RE: **James Dwyer Substation Parking Lot Expansion**  
**12700 Montgomery NE**  
**Grading and Drainage Plan**  
**Engineer's Stamp Date: 2/1/19**  
**Hydrology File: G23D011**

Based on the submittal received on 2/4/19, the Grading Plan cannot be approved for Grading or Paving Permit until the following are corrected:

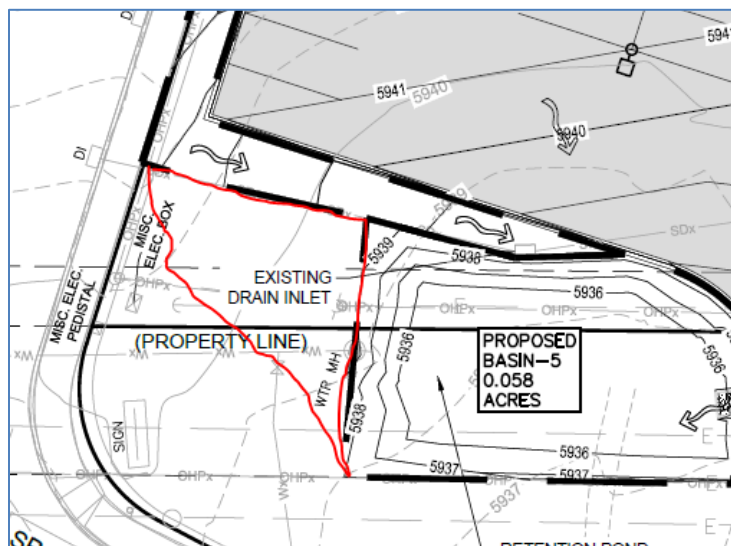
1. The pond needs to be sized for the undeveloped area between the pond and Montgomery, as this area drains into it also:

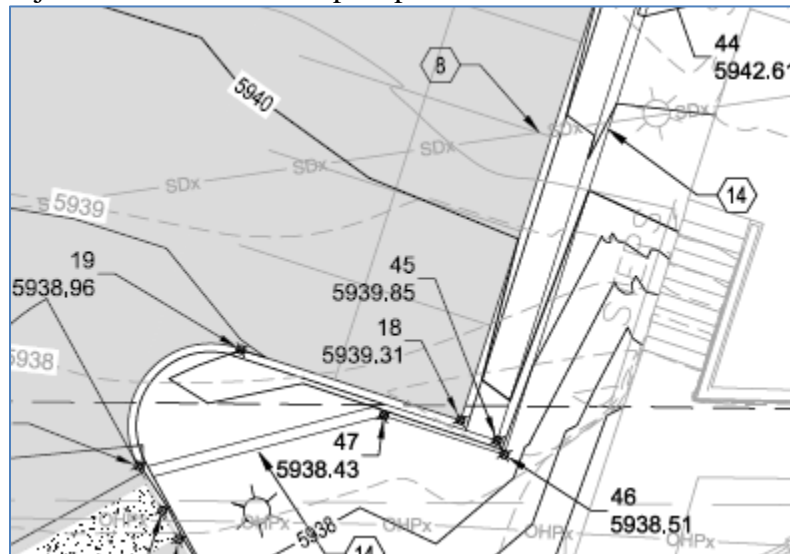
3. Provide an armored swale between the parking lot and back of sidewalk on Montgomery to convey flows to the pond.
4. Provide sections and hydraulic capacity calculations for the valley gutter/drive entrance. It seems as though peak flows will jump the valley gutter and continue out the drive entrance, bypassing the pond.
5. Provide additional spot elevations and grade-to-drain notes to ensure ponding does not occur at the SW corner of the parking lot. Also provide erosion protection between this corner and the adjacent stairs on the steep slope:

TITLE: JAMES DWYER SUBSTATION PARKING LOT EXPANSION DRAINAGE PLAN

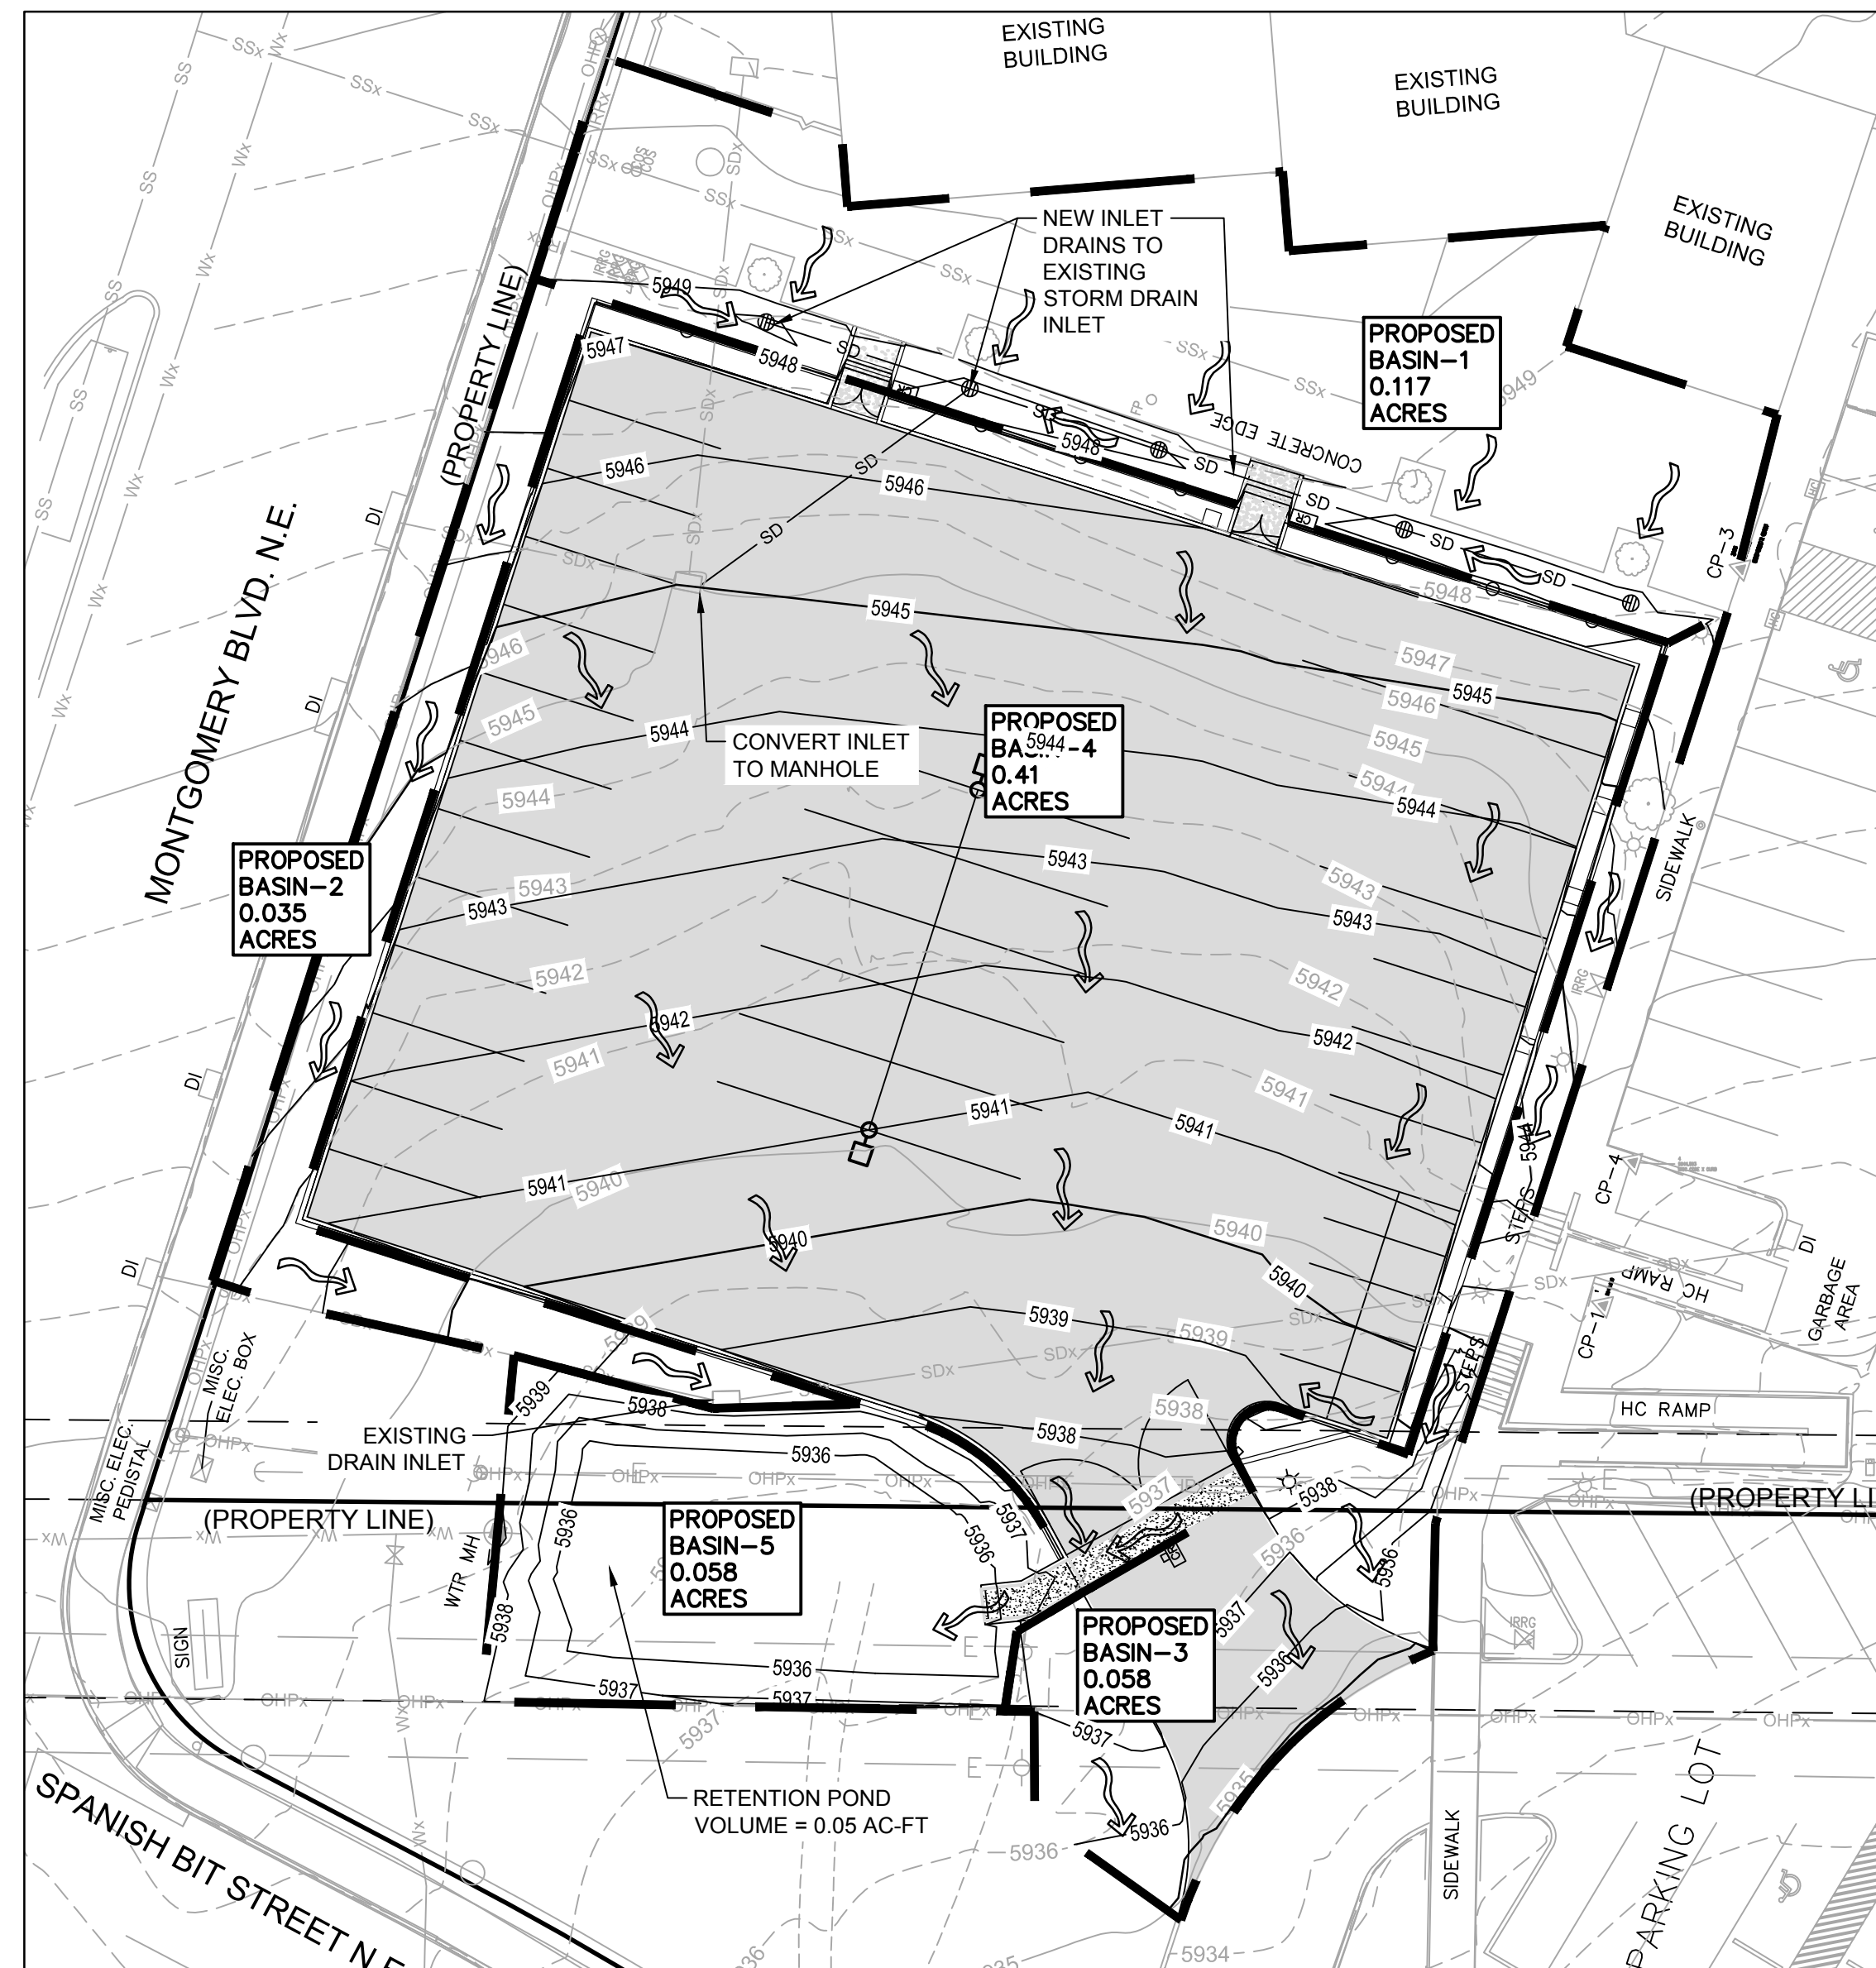
2. Because this pond serves as a detention pond, provide a primary outfall to the public ROW and include pond routing calculations and the storage-discharge curve. It'll also need an emergency spillway, sized for the 100-yr peak inflow. Alternatively, the pond can be converted to a retention pond if it is upsized to retain the 100-yr, 10-day volume. If configured this way, pond routing calculations and primary outfall are not required.
